DEVIATION REQUEST AND DECISION FORM

Project Name:	Mountain View Academy
Schedule No.(s):	
Legal Description:	Tract H, Claremont Ranch Filing No. 4 as recorded under Reception No. 204062712 of the records of the El Paso County Clerk and Recorder, County of El Paso, State of Colorado, containing 7.884 Acres or 343,420 Square Feet, more or less.

A deviation from the standards in Appendix I, Section I.7.3 of the Engineering Criteria Manual (ECM) which states that WQCV ponds should be incorporated into Minor- and 100-Year Storm Stormwater Detention Structures is requested. This deviation request also applies to Chapter 13 of the Drainage Criteria Manual Vol. 1 Update (DCM v1 update) regarding full-spectrum ponds and EURV as well as Board of County Commissioners resolution 15-042 stating that the “most restrictive” requirements shall apply.

TYPICAL SECTION
 DESIGN SPEED = 30 MPH, LESS THAN 1,250 AADT
 MEADOW BROOK PARKWAY STA 26+15.78 TO STA 49+88.19
 NOT TO SCALE

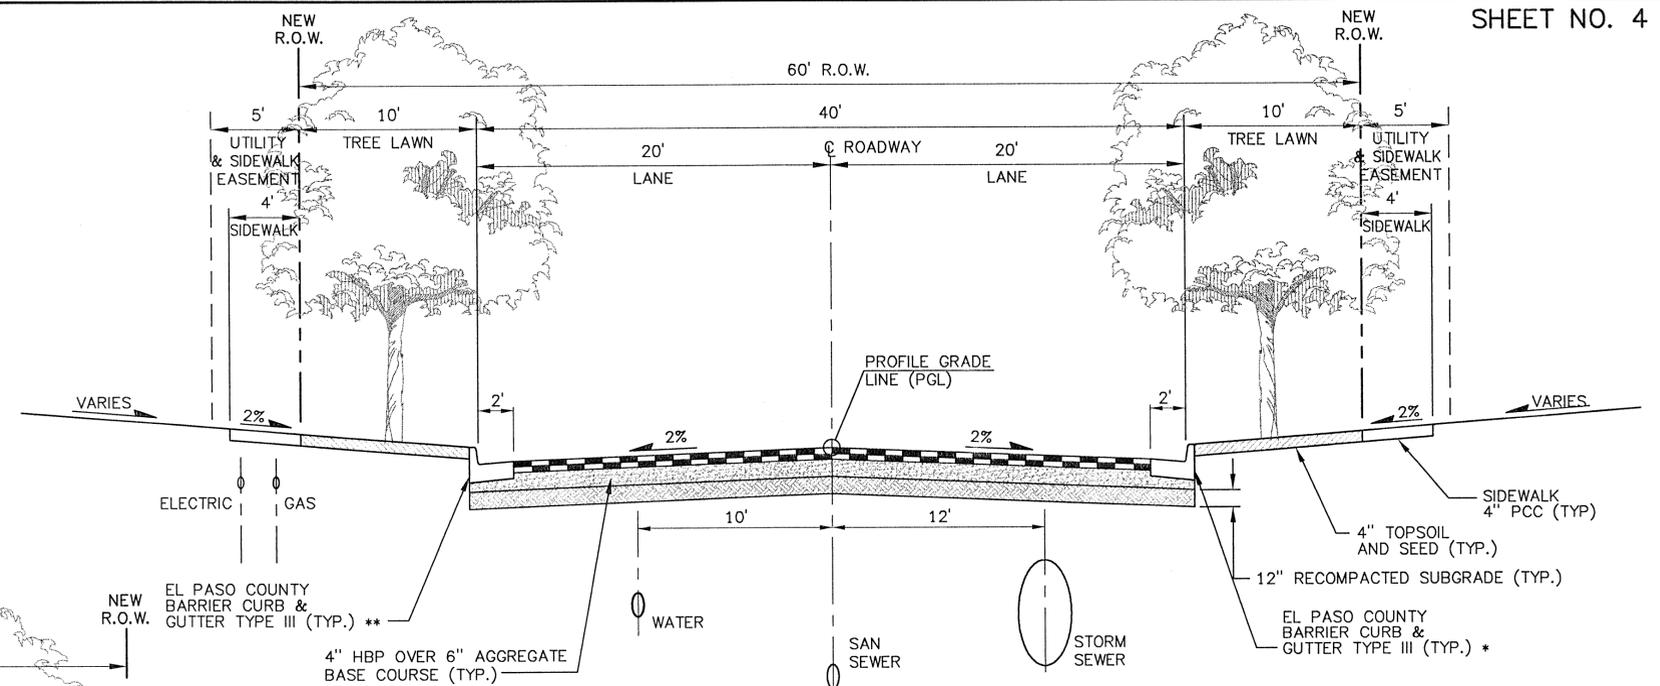
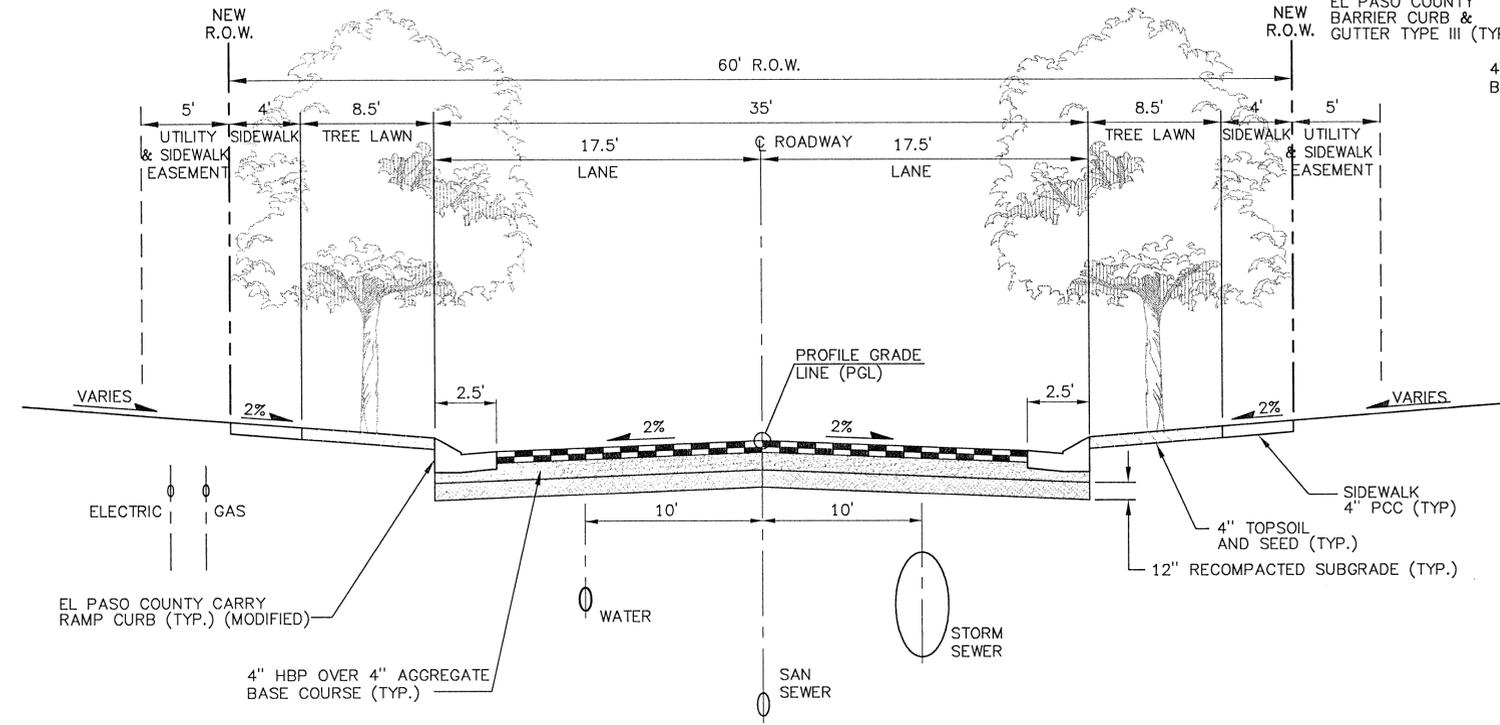
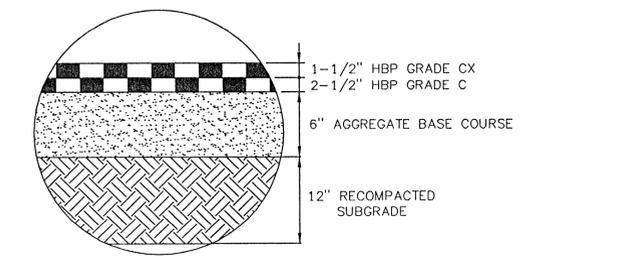
The Mountain View Academy project proposes to follow the general concept of the detached walk as shown in the approved plans for Claremont Ranch Filings 2, 3, and 4, with a modification to change the sidewalk width from 4-ft to 5-ft to adhere to current Americans with Disabilities Act guidelines. The 5-ft sidewalk width will meet the minimum requirements as shown in EPC Std Dwg SD2-2 and SD2-4, while still achieving a cohesive look with the rest of the subdivision. Refer to attached exhibit for proposed typical cross-sections.

As previously stated, the existing sidewalks throughout the adjacent neighborhood are 4-ft detached walks, which is consistent with both the approved construction documents (PCD File No SF01033, SF02014 and SF03012) and Development Plan for Claremont Ranch (PCD File No. PUD02005). The developer is proposing to install a 5-ft detached to meet the minimum sidewalk width required by the Americans with Disabilities guidelines while still adhering to the character of the surrounding area.

The approved Development Plan for Claremont Ranch (and subsequent Construction Documents for Filings 2, 3, and 4) call for a 4-ft detached walk as stated above. The deviation will keep with the character of the previously approved street sections, with the modification of increasing the sidewalk width to 5-ft.
